P.O.A.D.P.
SANTIKOS 281 / 1604

POADP APPLICATION

Re: Santikos 281 - 1604

RE: Santikos 281/1604 P.O.A.D.P.

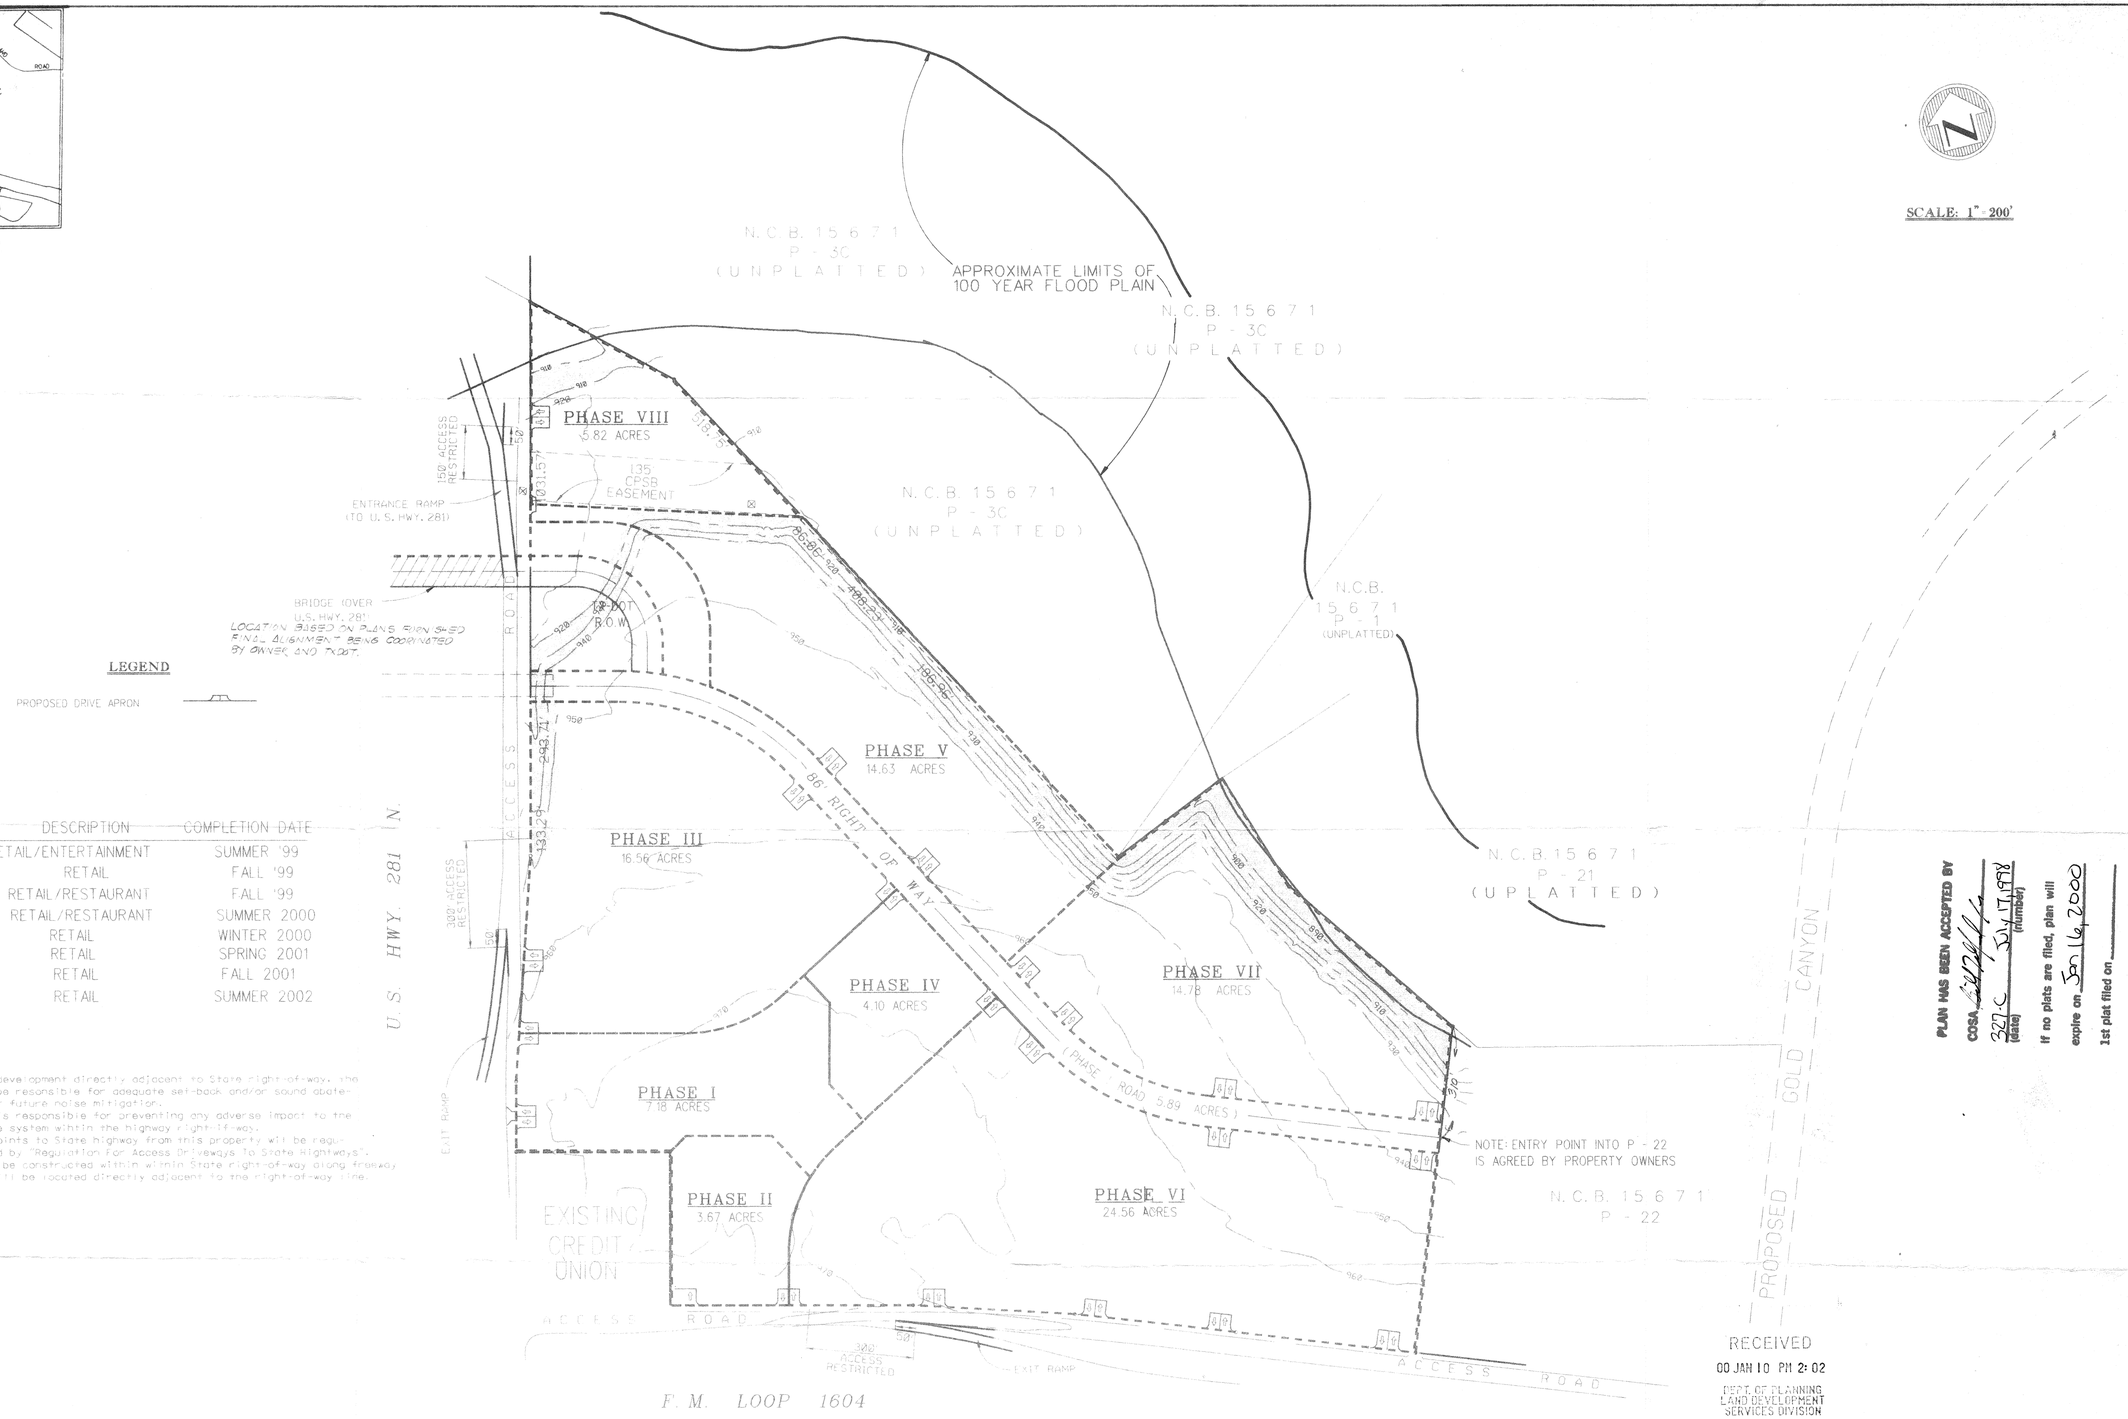
The City Staff Development Review Committee has reviewed Santikos 281 - 1604 Subdivision Preliminary Overall Area Development Plan # 327 - C. Please find enclosed a signed copy for your files. Although your plan was accepted, please note the following:

- Based on the topography, a Flood Plain Study and drainage review will probably be required during the platting process.
- In consideration of public safety and convenience, excessive grades by reason of topography should be avoided in street layouts and arrangements.

- This development will probably need to conform to requirements associated with development over the Edwards Aquifer. For additional information about these requirements you can contact SAWS at 704-7305.

- Access and R.O.W. issues along State facilities will need to be resolved with the Texas Department of Transportation (TXDOT). For information about these requirements you can contact TXDOT at 615-5814.

- The east-west alignment will need to be coordinated with the adjacent property owners.
- This development will need to comply with tree preservation ordinance #85262. For information about these requirements you can contact Building Inspections at 207-7102.

- It will be expected that you will plat all of the property depicted in your POADP, to include: floodpains, drainage areas and open space.

REVISIONS: DATE	NO.	DESCRIPTION	BY
6/18/98	1	REVISED PER CITY COMMENTS	M.C.

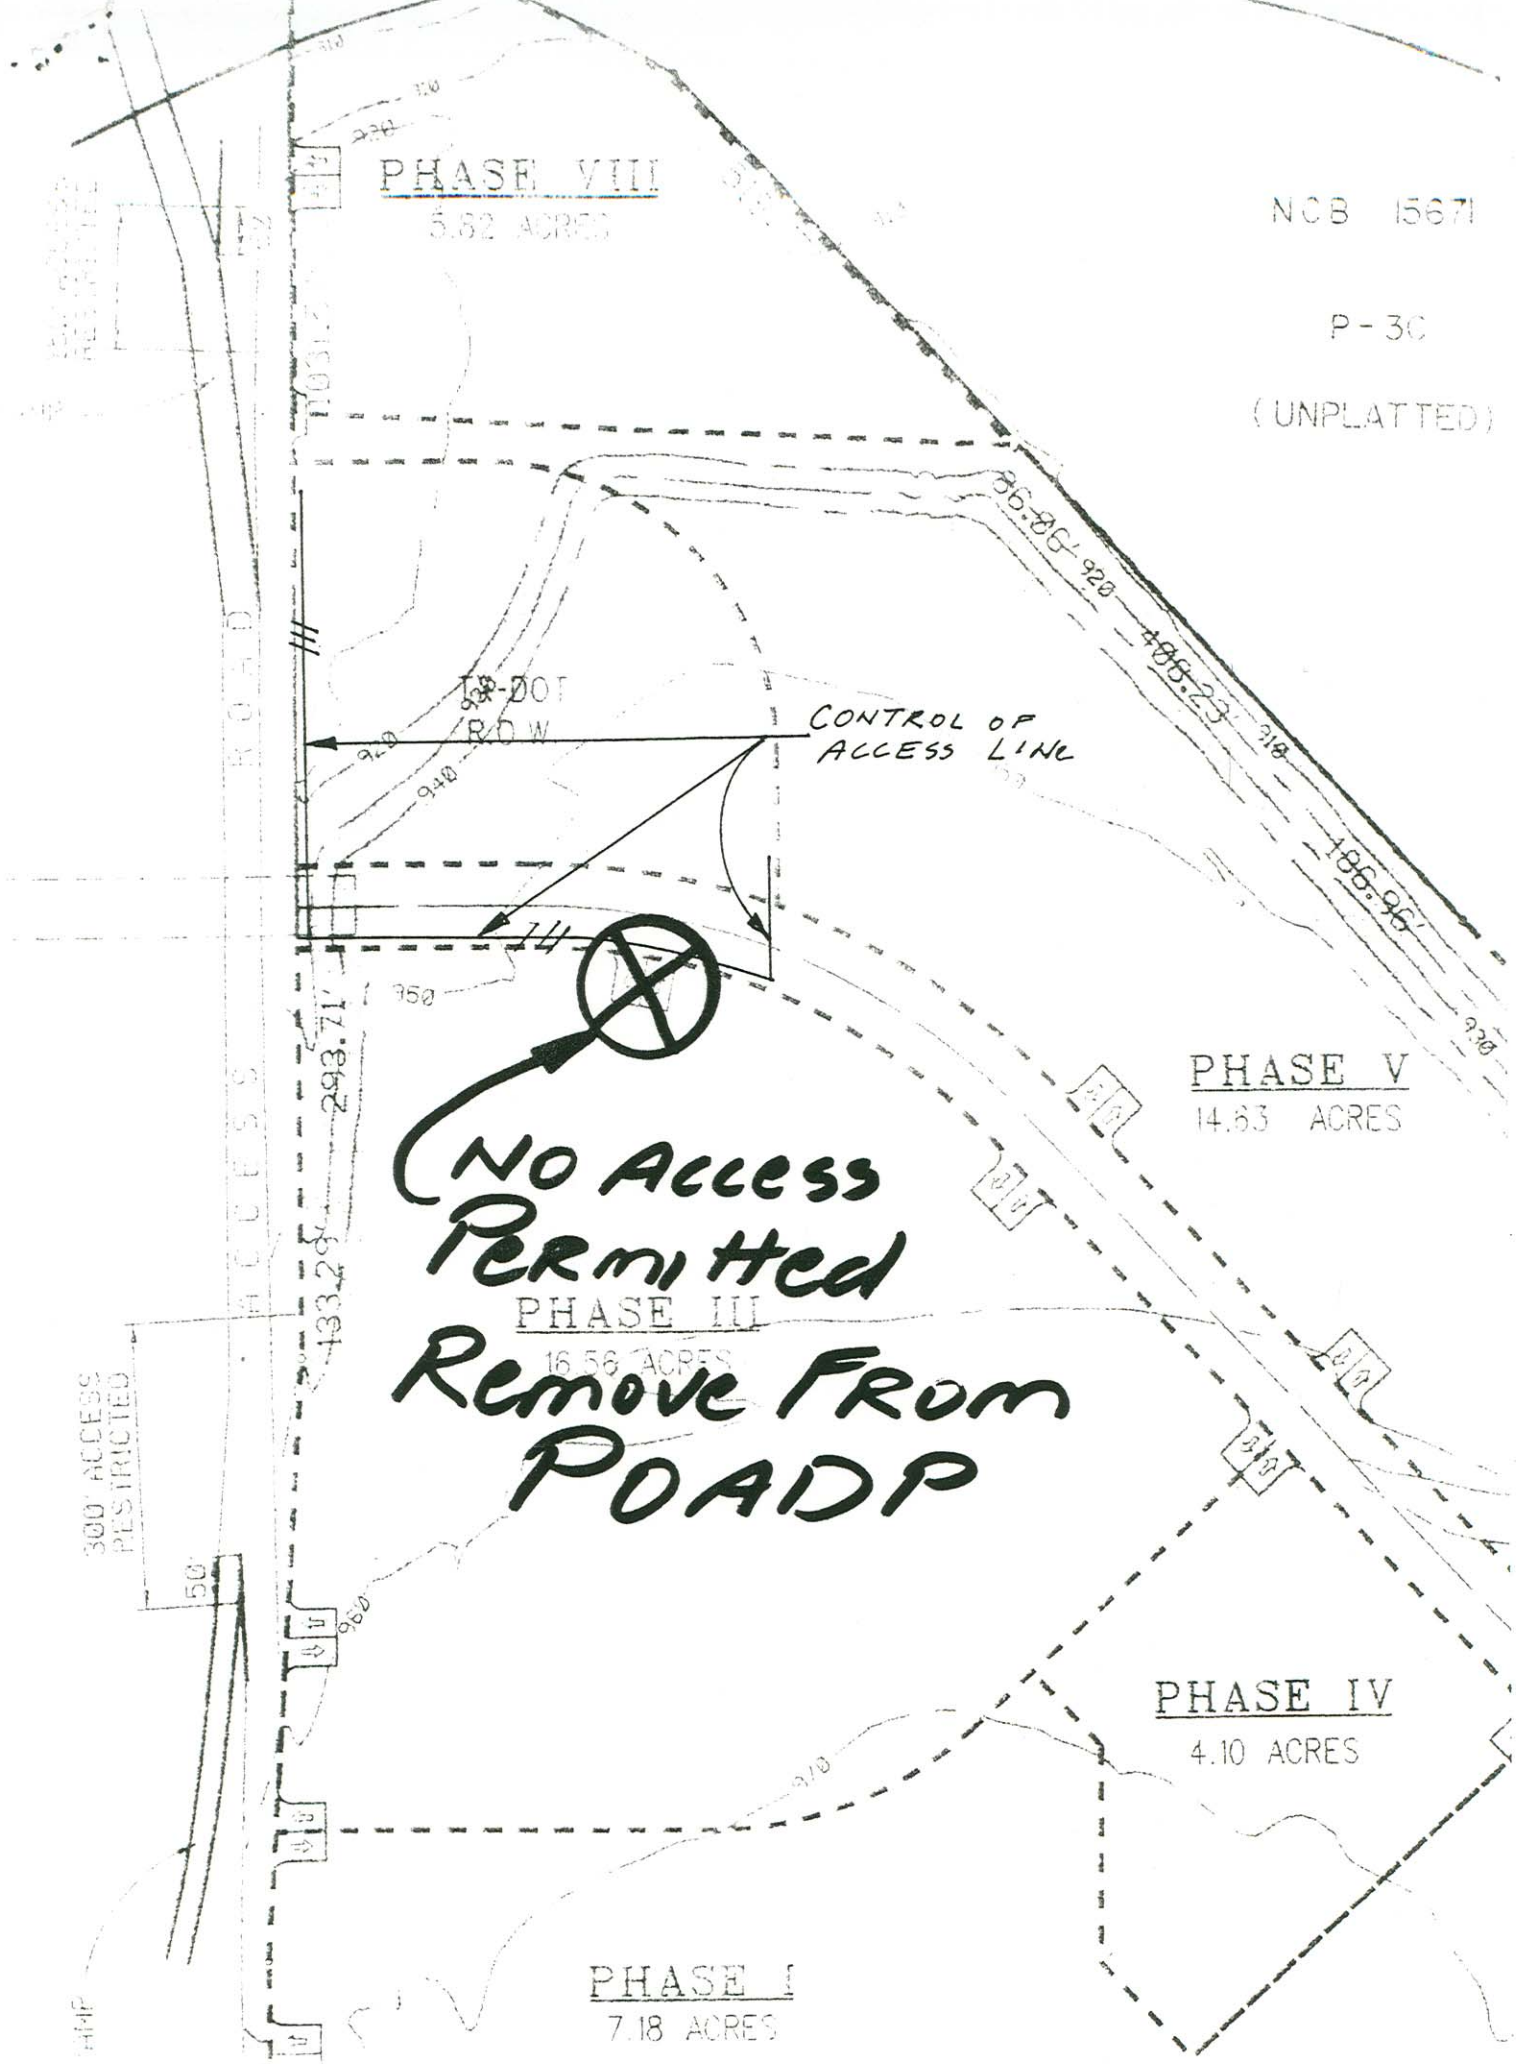
Our office has reviewed the layout of the referenced development and I have a concern that must be addressed and incorporated into this site layout.

As you are aware the Texas Department of Transportation is planning to construct an interchange between US 281 and the major thoroughfare known as Centre Park. Your layout indicates an access point at this interchange that is within TxDOT right of way. This access point is not acceptable and will not be permitted. Please refer to the attached layout.

The roadway schematic prepared by TxDOT, established control of access along the right of way at this interchange. This control of access issue was explained and understood in our meeting of January 1998, between TxDOT, Mr. Andrew Johnston (Santikos Investments), and your firm. As this development is in the preliminary stage, it is of the utmost importance that this access point be removed from the POADP. This will avoid future misconceptions of permissible access when this property is marketed and developed.

The locations of the access points along US 281 and Loop 1604 are acceptable as shown and will be the maximum permitted.

PHASE VIII
5.62 ACRES
NCB 15671
P-30
(UNPLATTED)
TX-DOT
R.O.W.
CONTROL OF
ACCESS LINE
PHASE V
14.63 ACRES
NO ACCESS
PERMITTED
PHASE III
16.56 ACRES
REMOVE FROM
POADP
300' ACCESS
RESTRICTED
PHASE IV
4.10 ACRES
PHASE I
7.18 ACRES
